REVISED RESPONSE TO REQUEST FOR ADDITIONAL INFORMATION

APR1400 Design Certification

Docket No. 52-046

RAI No.: 343-8420

Figure 1. Tank Levels of the Holdup Tank.

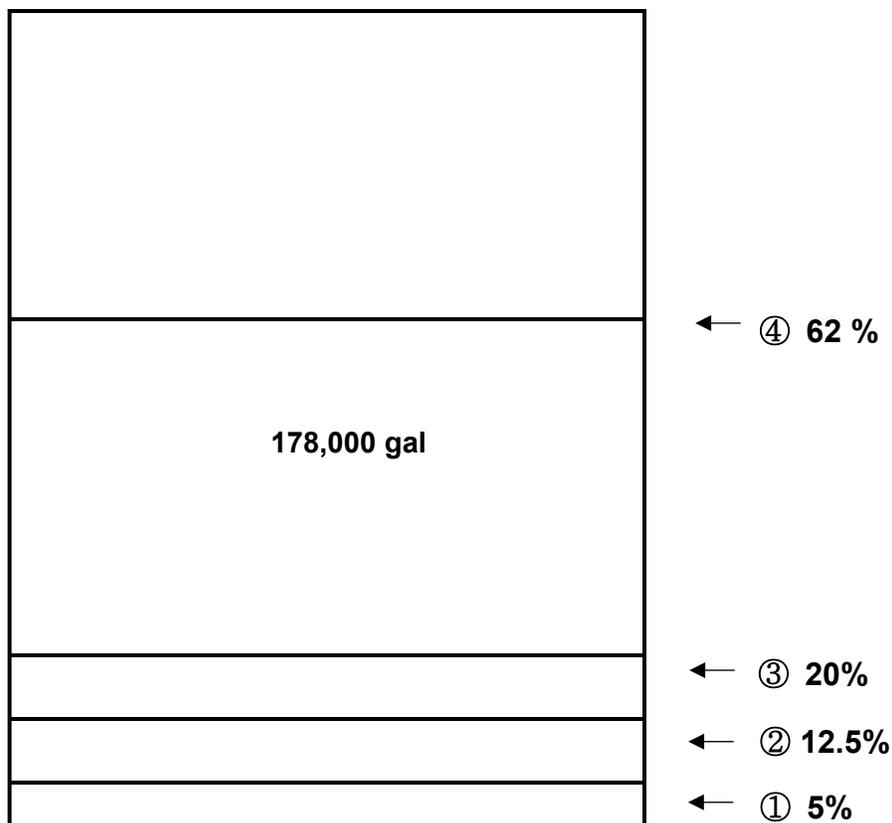
1. In the response to Question 12.02-2 and 12.02-3, the applicant provided source term information for tanks containing liquid radioactive material. The source term information indicated that the source terms used for radiation shielding and zoning for many of the tanks was based on the tanks being filled to only a small fraction of the tanks' total volume. Since the SRP specifies that zoning (and therefore shielding) should be based on the maximum dose rate, it isn't appropriate that the maximum designed dose rates would be based on a fraction of the total tank volume. Examples include the following:

- a. Holdup Tank – 12.5% full (See response to Question 12.2-3, FSAR Table 12.2-25 markup).
 - b. Boric Acid Storage Tank - 50% full (See response to Question 12.2-3, FSAR Table 12.2-25 markup).

5. In part 5 of question 12.02-3, the staff requested that the applicant provide the methods, models, and assumptions used in calculating the source term for the holdup tank, in accordance with SRP Section 12.2. While the applicant provided the general methods, models, and assumptions used, they did not provide the quantity of material associated with each input path to the holdup tank. Therefore, it is unclear that the assumptions for input pathways to the holdup tank are conservative or reasonable for determining the maximum source term for zoning and shielding.

- ① Low Level Fraction (5%) : It is equal to the low level alarm setpoint which is based on the minimum tank volume required to supply the minimum NPSH to the holdup pumps with instrument channel accuracy.
- ③ High Level Fraction (20%) : It is equal to the high level alarm setpoint which is set to accommodate water volume for one cold shutdown and subsequent startup, and indicates that tank processing needs to be initiated. This level is the highest level for normal power operation from the beginning of fuel cycle except the shutdown operation.
- ③~④ Additional inflow volume (42%) from shutdown operation.

- 1) To calculate HUT vapor activity, the low level fraction (5%) is used in order to maximize vapor space activities.
- 2) To calculate HUT liquid activity, the water level (62%) is used in order to maximize liquid space activities. This level (62%) includes the normal power operation volume (20%) and additional inflow volume (42%) from shutdown, refueling operation and startup operations for shutdown operation.

- ② The shielding calculation of the Holdup Tank includes the use of liquid and vapor phase design basis source terms at 0.25% failed fuel fraction. The liquid phase volume uses 12.5% of the total tank volume, but the source term includes the radioactivity for the

maximum water level 62%, concentrated to the 12.5% liquid volume. The shielding calculation also includes the vapor phase radioactivity at 87.5% tank volume, which is based on that of noble gases. The radioactivity from the noble gases is higher than that of the liquid, contributing to about 90% of the shielding source terms. Hence the summation of these two source terms and calculation method results a more conservative shielding design for the Holdup Tank.

Please note that the 12.5% volume is an artificial assumption to adjust liquid and vapor phase volumes to 100% in order to maximize the vapor phase volume and source term. Even though that the liquid volume can be as high as 62%, the combined source terms for shielding calculation are based on a liquid volume of 12.5% and a vapor phase volume of 87.5% in order to make the conservative shielding source terms.

Figure 2. Tank Levels of the Boric Acid Storage Tank.

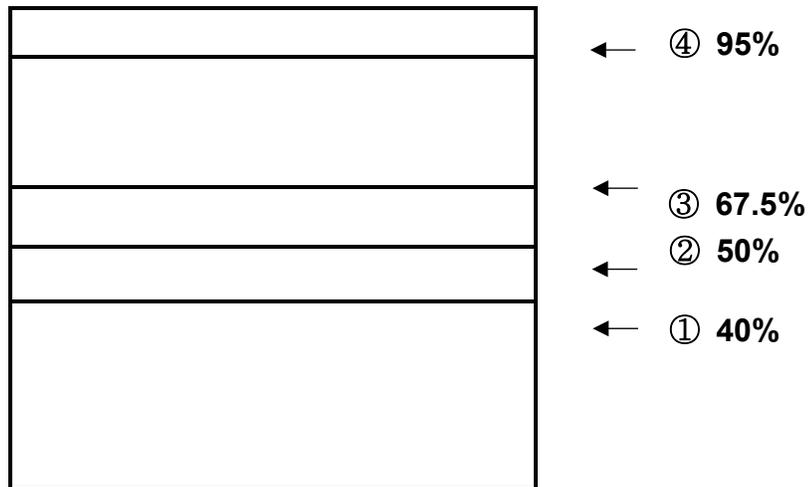
6. In the response to Question 12.02-3, the applicant indicates that the holdup tank and boric acid storage tank will be surrounded by concrete shielding on all sides, from the bottom to the top of the tanks, with no gap between the tank surface and the concrete, and that the dose rate outside the concrete will be less than 0.25 mrem/hour. However, there does not appear to be any shielding provided on the top of the tanks and the dose rate on the top of the tanks is not discussed. The Auxiliary Building is located near these tanks in FSAR Figure 1.2-1 and it is unclear if these tanks could result in elevated dose rates on the Auxiliary Building roof or other elevated areas that could result in dose to workers or members of the public.

- ① Low Level Fraction (40 %) : It is equal to the low level alarm setpoint which is based on the minimum tank volume required for one cold shutdown and subsequent startup, and indicates that filling of the tank needs to be initiated.
- ④ High Level Fraction (95 %) : It is equal to the high level alarm setpoint , which is used to warn of possible tank overflow and indicates that filling of the tank needs to be secured.

To calculate the BAST(liquid and vapor) activity, the average liquid level (67.5%) of ① and ④ has been used.

The calculation method for the BAST activity is changed to use the low and high level fraction instead of the average liquid level as follows;

- ① To calculate BAST vapor activity, the low level fraction (40 %) is used in order to maximize vapor space activity.
- ④ To calculate BAST liquid activity, the high level fraction (95 %) is used to maximize liquid space activity.

The shielding calculations for BAST and HUT were re-performed using the revised source terms determined based on the new method described above. As a result, the minimum required shield thicknesses for these components are increased due to the increase of the source terms. However, it is not required to change the structure design since the current structure thicknesses meet the increased minimum shield thicknesses.

Figure 3. Tank Levels of the Reactor Makeup Water Tank.

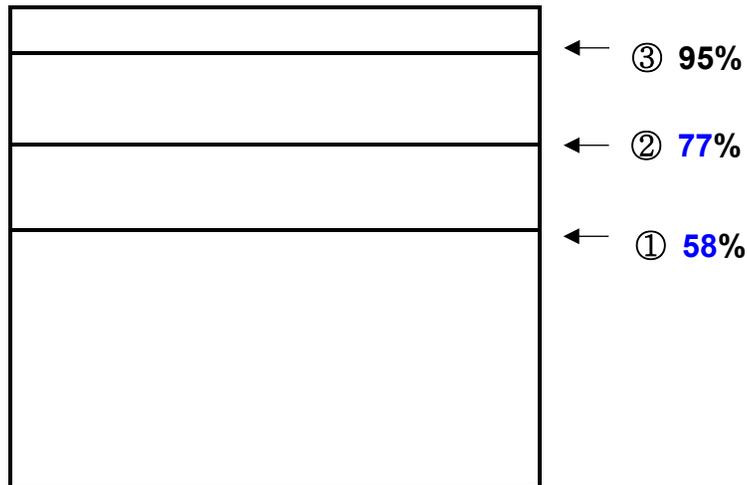
- c. Reactor Makeup Water Tank – 80% full (See response to Question 12.2-3, FSAR Table 12.2-25 markup).
 - d. Reactor Drain Tank – 62% full (See response to Question 12.02-2, FSAR Table 12.2-25 markup)

- ① Low Level Fraction (58%) : It is equal to the low level alarm setpoint which is based on the minimum water volume required for one cold shutdown and subsequent startup and indicates that filling of the tank needs to be initiated.
- ③ High Level Fraction (95 %) : It is equal to the high level alarm setpoint, which is used to warn of possible tank overflow and indicates that filling of the tank needs to be secured.

- ① To calculate RMWT vapor activity, the low level fraction (58%) is used in order to maximize vapor space activity.
- ③ To calculate RMWT liquid activity, the high level fraction (95 %) is used to maximize liquid space activity.

The results with the change in RMWT water level are given in the revised response to RAI 13-7856 Question 12.02-2 Rev.3 for the RMWT and Attachment 2 of this response for the RMW filter. The activities of RMW filter are affected because it is located at the downstream of RMWT.

Figure 4. Tank Levels of the Reactor Drain Tank.

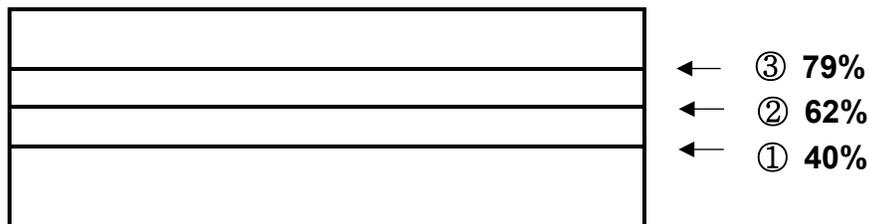
- b. In the response to Question 12.02-2, the applicant provides Table 5 on Page 8 of 13. The applicant indicates that "Case 2" in Table 5 provides assumptions used in the shielding calculations, however, in the proposed markup to FSAR Table 12.2-25, "Radioactive Source Dimensions and Parameters Used in Shielding Analysis," the applicant provides a different liquid water volume for the Reactor Drain Tank than is provided in Case 2. Case 2 indicates the liquid volume fraction is 73% and the revised Table 12.2-25 indicates that it is 62%. Please correct this discrepancy.

- b. The water and vapor fraction of the reactor drain tank source terms provided in DCD Table 12.2-25 was revised as indicated in Attachment 2 of response to RAI 13-7856 Question 12.02-2_Rev.4 [ML17093A969].

Figure 5. Tank Levels of the Equipment Drain Tank

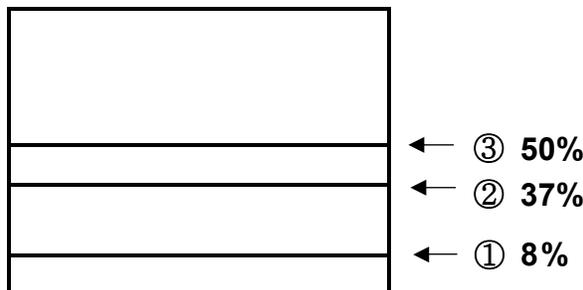
- e. Equipment Drain Tank – 37% full (See response to Question 12.02-2, FSAR Table 12.2-28 markup)
 - f. IRWST – 75% full (See response to Question 12.02-2, FSAR Table 12.2-25 markup)

- c. The revised Equipment Drain Tank dimensions provided in FSAR Table 12.2-25 indicate a significantly different volume than the volume provided in FSAR Table 9.3.4-2. Please correct this discrepancy.

- ③ The shielding calculation of the equipment drain tank (EDT) includes the use of liquid and vapor phase design basis source terms at 0.25% failed fuel fraction. The liquid phase models a volume of 50% of the total tank volume. The shielding calculation also includes a vapor phase radioactivity of noble gases at 50%, which is concentrated from 92% volume. The radioactivity from the noble gases is about 50 times higher than that of the liquid and dominates the total dose rate. Hence the summation of these two source terms and calculation method results a more conservative shielding design for the EDT.

- c. The discrepancy about EDT dimensions was corrected as indicated in Attachment 2 of the response to RAI 13-7856 Question 12.02-2_Rev.4 [ML17093A969].

Figure 6. Tank Levels of the In-containment Refueling Water Storage Tank

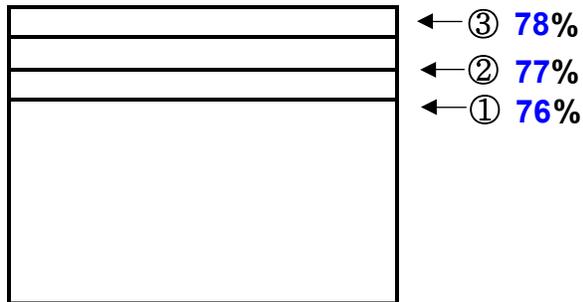
- e. The IRWST volume provided in the revised FSAR Table 12.2-25 is different from the volume provided in the new FSAR Table 12.2-28. Please correct this discrepancy.

Since the IRWST is located inside the containment and surrounded with the walls which have sufficient wall thickness for shielding, it is expected not to cause any significant impact on the plant structure design. Radiation zoning inside IRWST was determined based on the zoning for SFP since the source term of SFP is comparable to that of IRWST.

- e. The discrepancy about the IRWST volumes provided in DCD Tables 12.2-25 and 12.2-28 was corrected as indicated in the response to RAI 13-7856 Question 12.02-2_Rev.4 [ML17093A969].

Figure 8 Schematic Diagram for Leak Collection and Detection Design

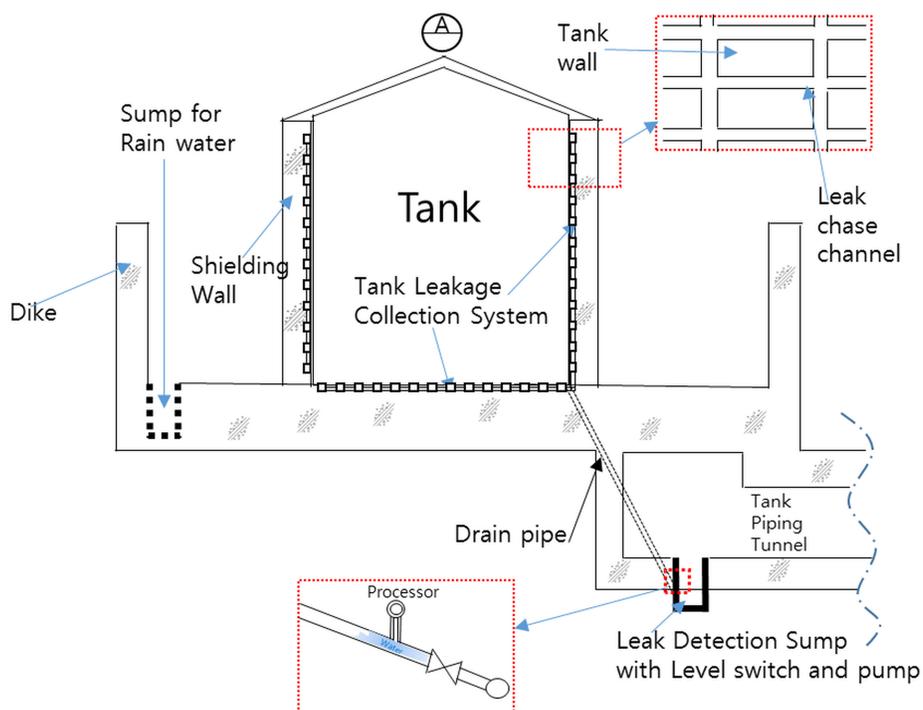
tank. Please specify how the above criteria from RG 8.8 is being met for these tanks and how tank inspections or repairs are to be performed on these tanks, while keeping worker dose ALARA.

In the event of tank leakage, the provision for the leak detection installed in the sump inside the tank piping tunnel (Refer to Figure 8) ensures early detection of the leakage. For the repair of the tanks, the tanks are drained and flushed with demineralized water to remove residual radioactivity and the leak or damaged area is identified. This repair work should be performed in accordance with the site radiation safety management procedures to minimize the exposure to the personal.

As illustrated in Figure 8 above, the rain water sump is designed to be separated from the outdoor tank leak detection sump, it is therefore not expected to contain radiologically contaminated water. Rain water collected is normally routed to the storm water system for discharge. In the rare event that leakage is detected in the outdoor tank leak detection sump, the content of the rain water sump is to be sampled and analyzed for contamination before it is discharged. It is noted that the outdoor tank leak detection sump discharge is connected to the radioactive drain system (DE). Contaminated rain water can be directed to the DE system, from which the rain water is then routed to the liquid radwaste system for processing and discharge.

Figure 9.3.4-1 Chemical and Volume Control System Flow Diagram (6 of 7)

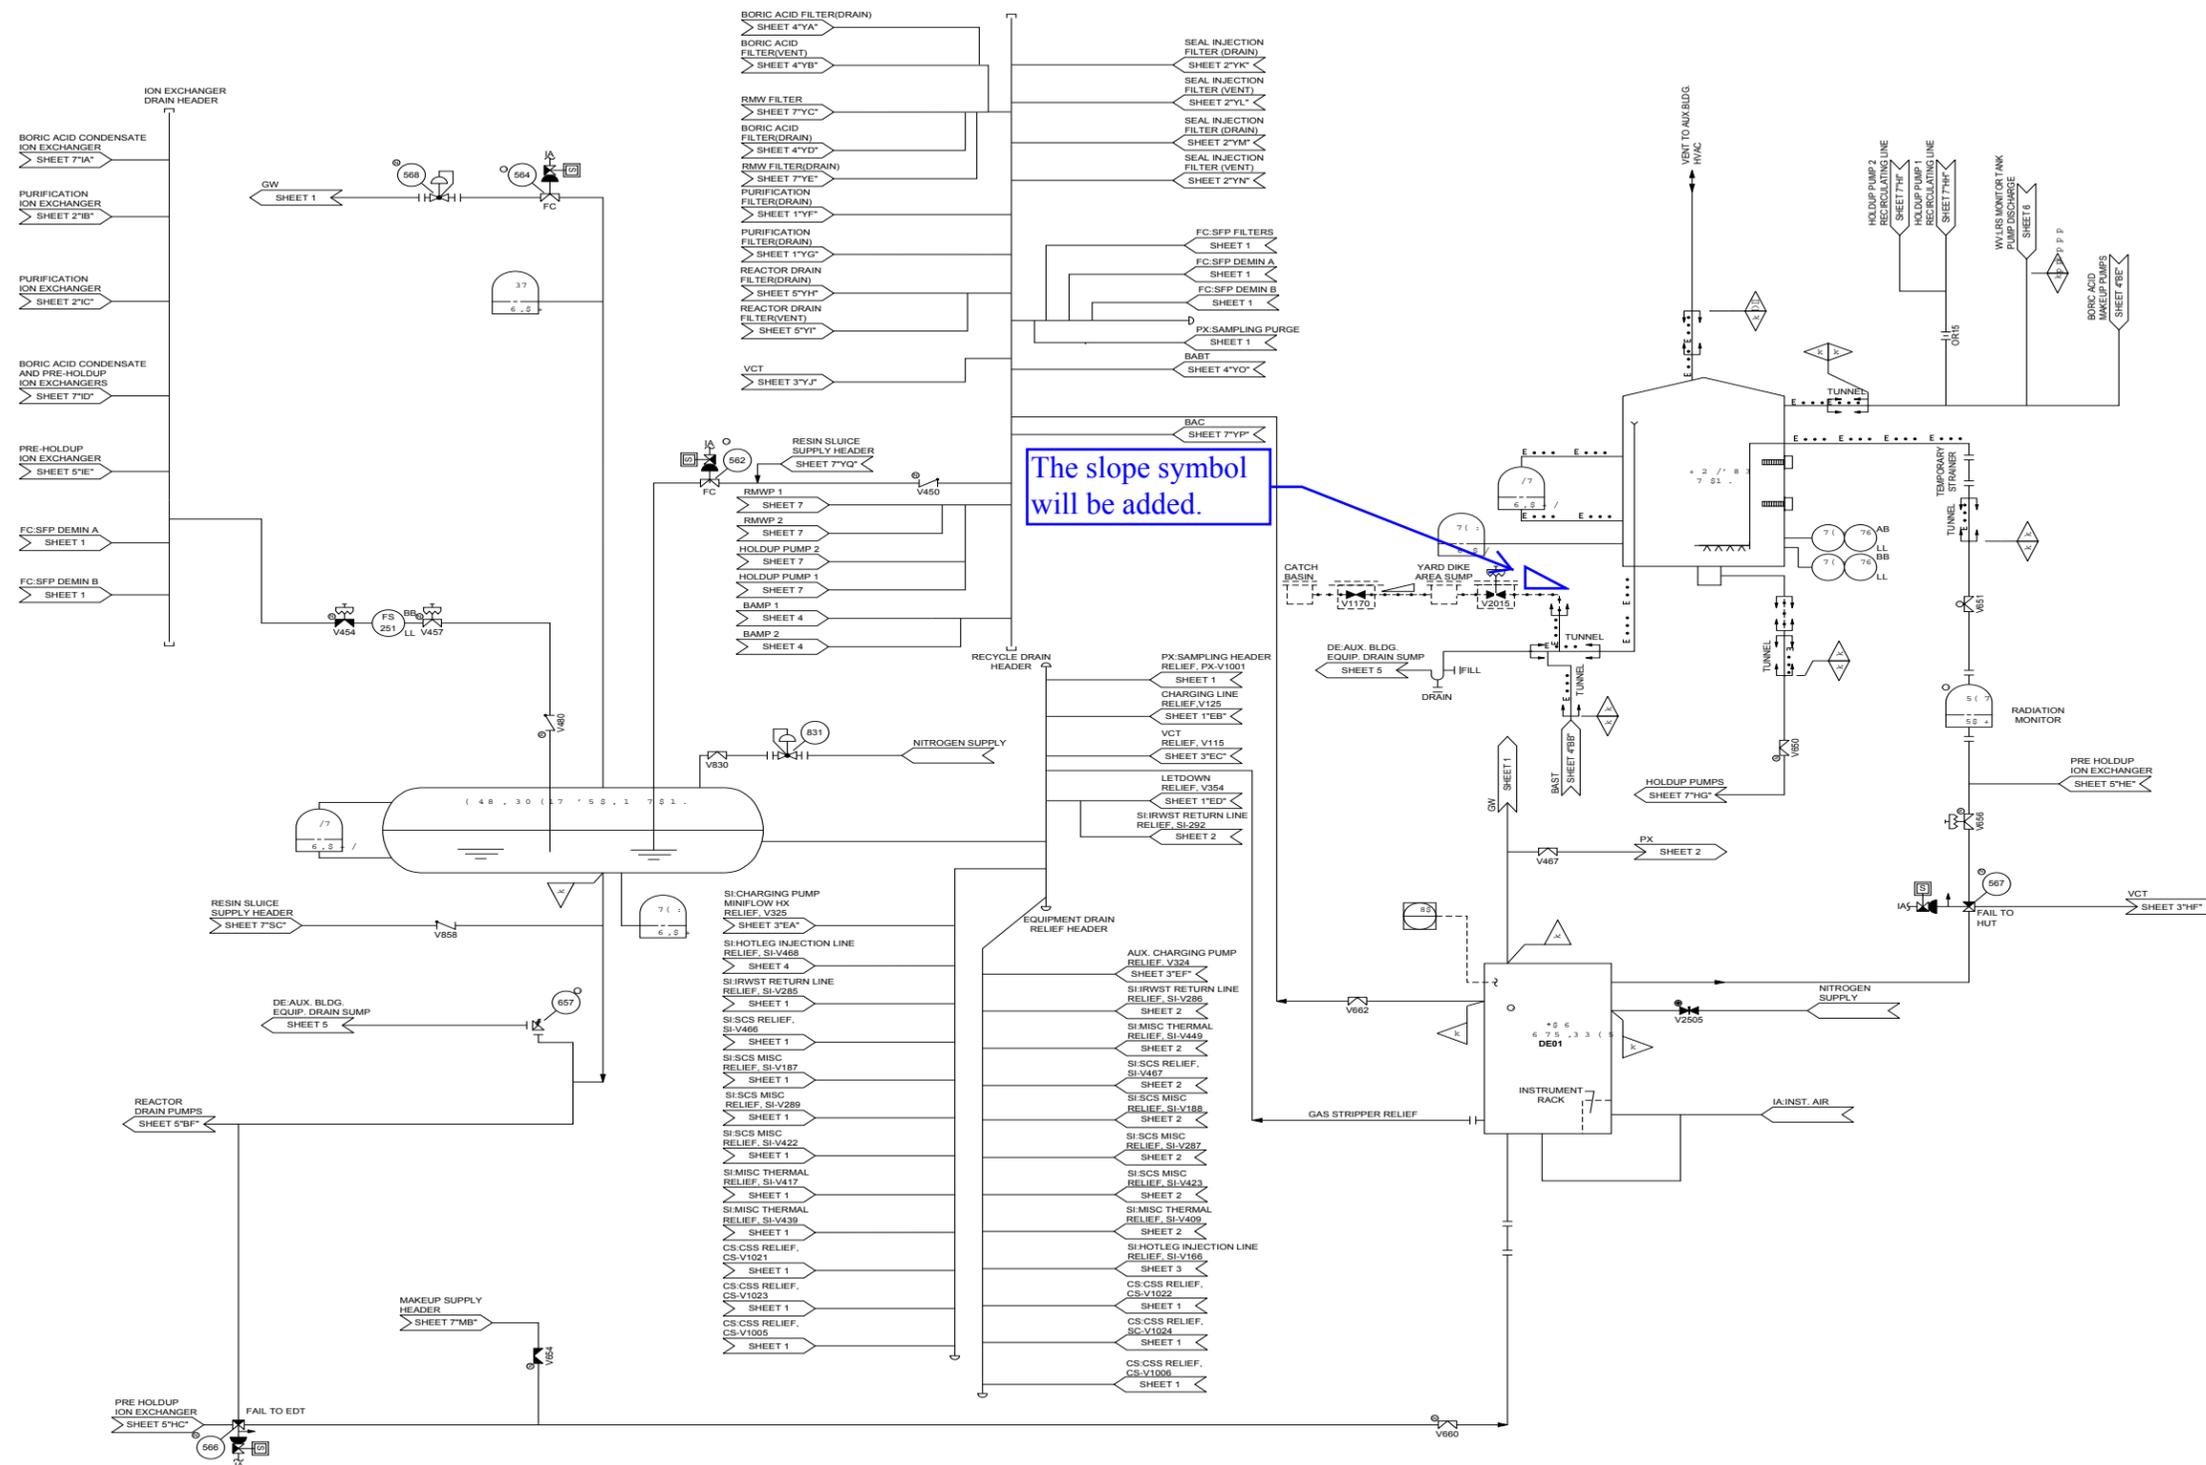
Since radiation exposure could result from accessing areas above the tanks please justify why no radiation shielding is needed for above the top of the tanks. In the response, indicate if there is expected to be a need for individuals to access the Auxiliary Building roof or other nearby areas above the tanks on a routine basis (e.g. security guard station). If so, please evaluate the dose rate to these areas and provide shielding, as appropriate, to ensure doses are ALARA. Update the FSAR, as appropriate.

The water levels of BAST and HUT are monitored and the high level of each tank is annunciated independently in the main control room. These tanks is also equipped with an internal overflow outlet, any overflow of the water in these two tanks are collected and routed to the equipment drain sump inside the AB as shown in DCD Figures 9.3.4-1 (sheet 4 and sheet 6) and 9.3.3-1 (sheet 5). The

isolation valve and the overflow drain line is sloped to prevent overflow back flowing to the dike sump. With the sloped piping and isolation valve, the overflow water from BAST and HUT flows to the equipment drain sump, and is not released to the dike sump as shown in DCD Figures 9.3.4-1 (sheet 4 and sheet 6).

The water level of RMWT is monitored by a level instrument. At high water level, the level instrument initiates an alarm in the MCR for the operator actions. Therefore, the water level of RMWT is controlled and unmonitored release of overflow is prevented. The slope symbol will be added in Figure 9.3.4-1 (sheet 6) as shown in the Attachment 6.

DCD Figure 9.3.4-1 will be revised as indicated in Attachment 6 DCD Figure 12.3-9 will be revised as shown in Attachment 4.
